Subject: **Docket Nos. 50-361 and 50-362**  
**Response to Request for Additional Information Regarding**  
**Proposed Technical Specification Change Number 454**  
**San Onofre Nuclear Generating Station Units 2 and 3**

**SAN ONOFRE NUCLEAR GENERATING STATION  
UNITS 2 AND 3 (SONGS 2 & 3)  
RESPONSES TO NRC REQUEST  
FOR ADDITIONAL INFORMATION  
ON PCN-454**

CALCULATION E4C-082

FIGURE 1  
PSS/E & TEST VOLTAGE PROFILES FOR 2A04

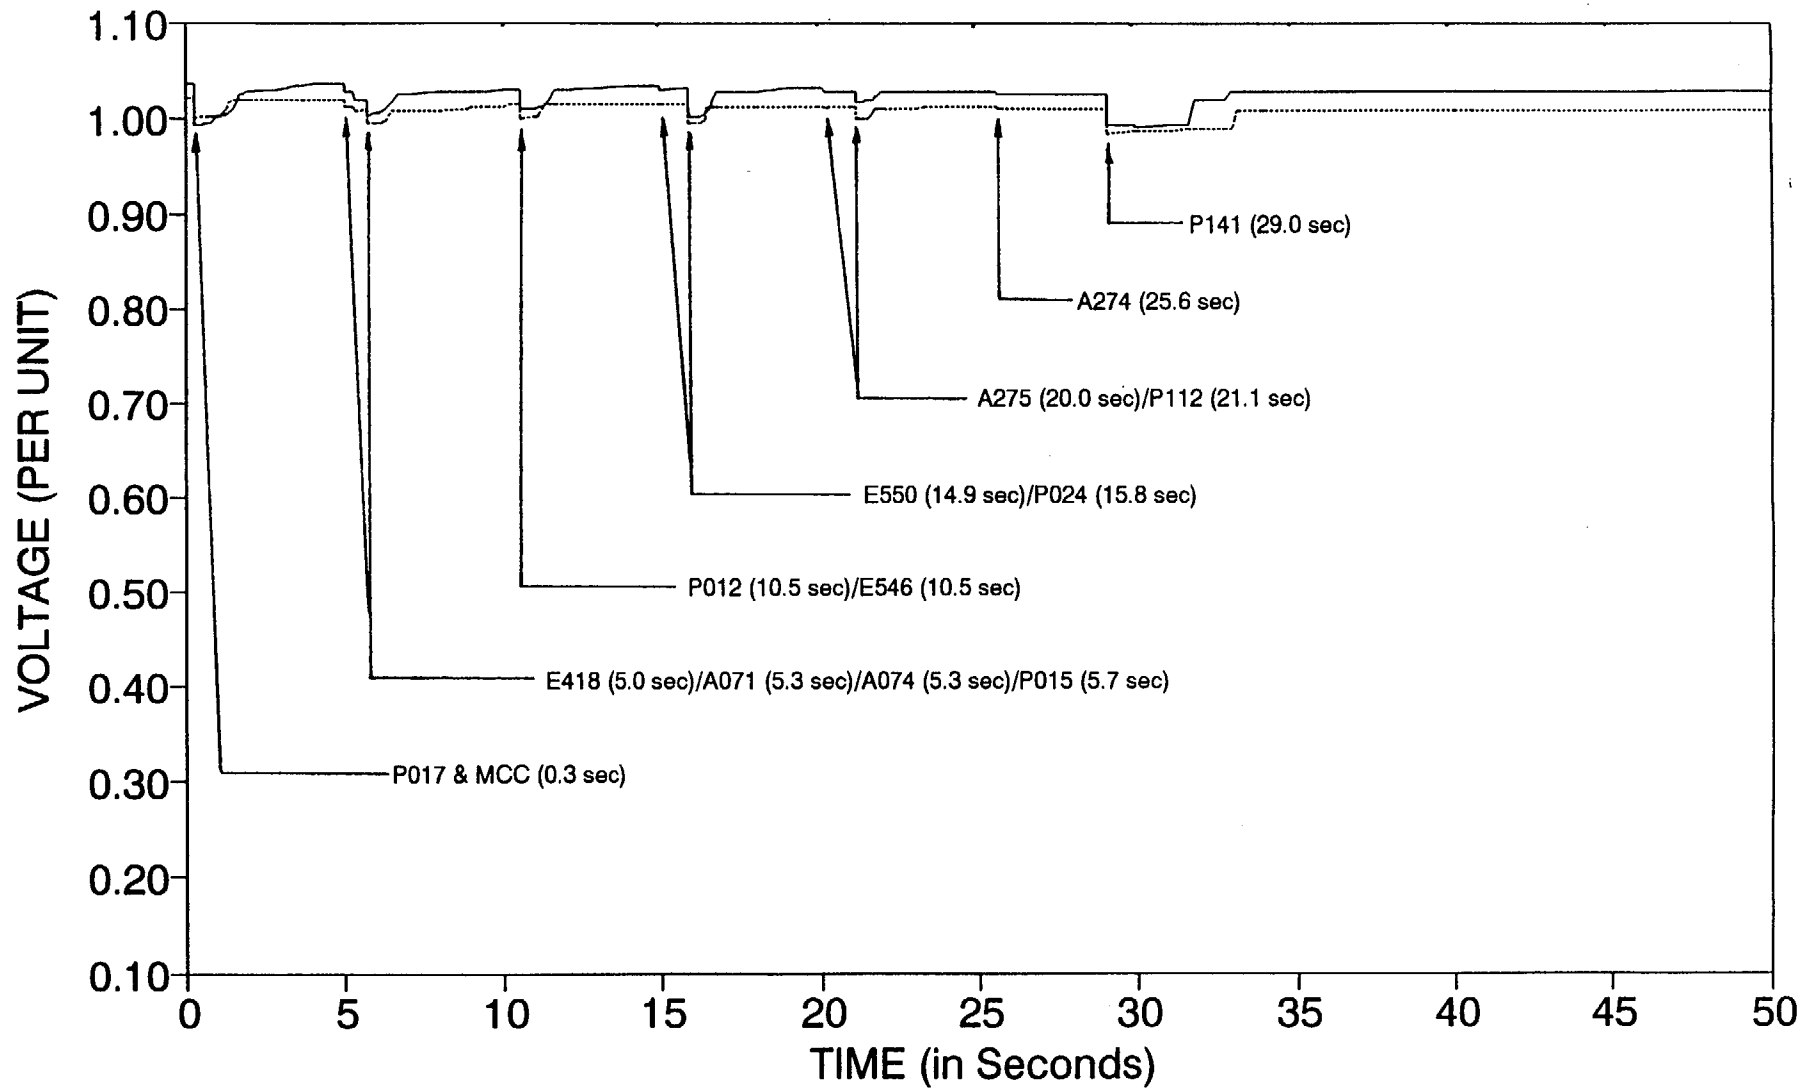
Software Modeling Verification (Enclosure 1, Page 11 of 15) - You stated that analytical techniques and assumptions used in voltage analyses were verified against actual measurements. Please provide details (i.e., minimum voltage at the motor terminals, steady state voltage, acceleration time, and so forth).

PSS/E Program verification was accomplished by simulating a portion of the pre-operational Transformer Voltage Tap Verification test for SONGS Unit 2, and comparing the results of the test with the results of the PSS/E Program simulations. During this test, the dynamic and steady state voltages at the ESF 4.16 KV buses were monitored by a recorder. In the PSS/E dynamic simulation, system loads were adjusted to match the actual test conditions. Each ESF load was then simulated to start at the same time it was started in the actual test. The voltage profiles resulting from the dynamic simulations were then compared with the voltage profiles from the actual test. The resulting plots from the dynamic simulations and actual test were then superimposed for comparison (Figures 1 and 2 of the Attachment to this response document). The steady state voltages from the test and PSS/E verification are tabulated below for comparison.

BUS NO.	TEST RESULTS	PSS/E RESULTS
2A04	4.27 KV	4.1966 KV
2A06	4.24 KV	4.1887 KV

During the test, motor terminal voltages were not measured. Motor acceleration times can be verified by inspection of the voltage profiles.
